This document addresses known errata and documentation issues for the FFT MegaCore® function version 7.1. Errata are functional defects or errors, which may cause the FFT MegaCore function to deviate from published specifications. Documentation issues include errors, unclear descriptions, or omissions from current published specifications or product documents. [Table 1](#) shows the issues that affect the FFT MegaCore function v7.1.

FFT MegaCore Function v7.1 Issues

Incorrect Timing Diagrams in the User Guide

Figure 1. FFT Streaming Data Flow Architecture Simulation

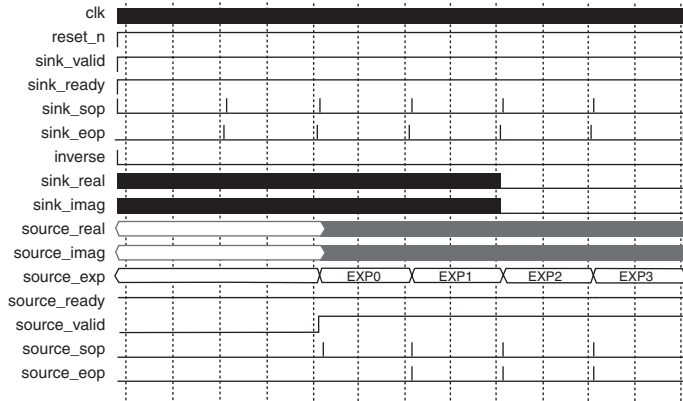
The following figures are incorrect in the user guide:

- Figure 3-3
- Figure 3-4
- Figure 3-12
- Figure 3-15

[Figures 1 to 4](#) show the correct figures.
